Product / Process Change Notification (PCN)

PCN #: PCN_IndGF_20200207

Affected Series: WE-GF; 1210 744764xxx, 1812 744766xxx

current

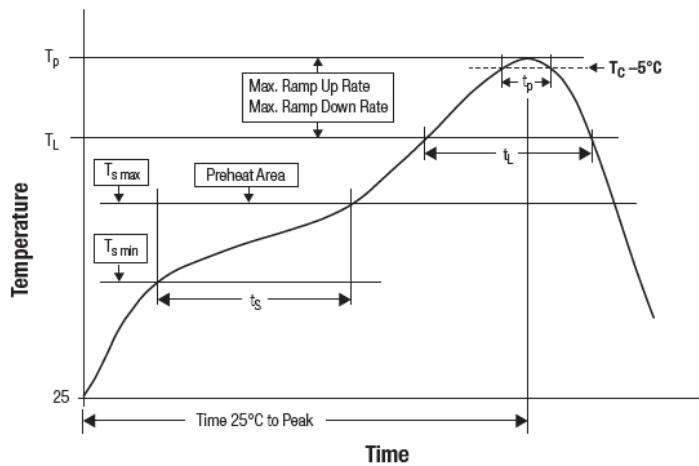
Because of a database mismatch, Würth Elektronik will correct the reflow specification to 245°C max. for 10s max. and will correct the MSL (moisture sensitivity level) to 3 in the datasheet of the product series WE-GF.

Reflow Profile:
